Intersection ID: 10026093	Main Street: ENGLAND_ST	Cross Street: N/A	Location:	SW
ADA ID: 2A9191BF9AAC	Ramp Type: PerpDiag	Initial Pass/Fail: Fail	Overall Compliance: No	Severity Score: 13.75

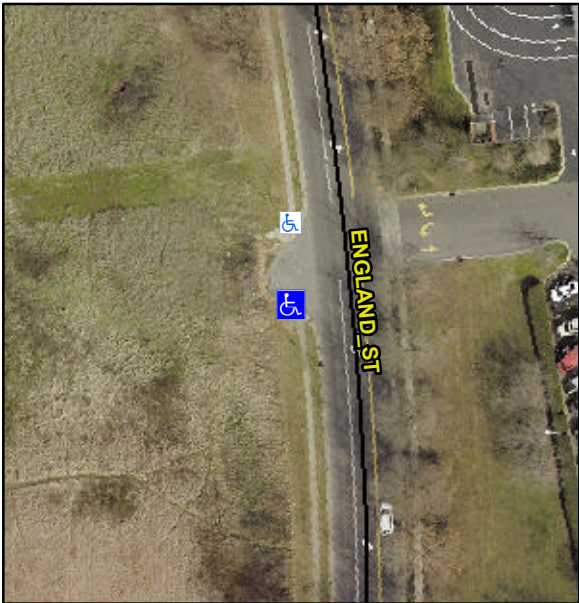
Codes/Mitigation Info/Possible Solution			Field Measurements/Component Compliance					
	Possible Solutions:		Compliance	Description	Data	Compliance	Description	Data
	<b>Remove &amp; Replace Curb Ramp With Two New Directional Ramps or Equivalent.</b>		N/A	Ramp Length (in)	80.0	No	Ramp Slope (%)	8.8
			Yes	Ramp Width (in)	48.0	Yes	Ramp XSlope (%)	2.4
			N/A	Flare Type LT	N/A	N/A	Flare Type RT	N/A
			N/A	Flare Slope LT (%)	N/A	N/A	Flare Slope RT (%)	N/A
			N/A	Flare Traversable LT?	N/A	N/A	Flare Traversable RT?	N/A
			N/A	Landing Length (in)	N/A	N/A	DWS Provided?	N/A
			N/A	Landing Width (in)	N/A	N/A	DWS Contrast?	N/A
			N/A	Landing Slope (%)	N/A	N/A	DWS Length (in)	N/A
			N/A	Landing X Slope (%)	N/A	N/A	DWS Full Width?	N/A
Surveyor Notes:		N/A	N/A	Landing Curb? (Y/N)	N/A	N/A	DWS Offset (in)	N/A
PROW/ADA:		Not Found, R304.2.2	N/A	Shared Landing?	N/A			
			N/A	Gutter Ponding?	N/A	N/A	Gutter Slope (%)	N/A
			N/A	Gutter Lip Ht (in)	N/A	N/A	Gutter X Slope (%)	N/A
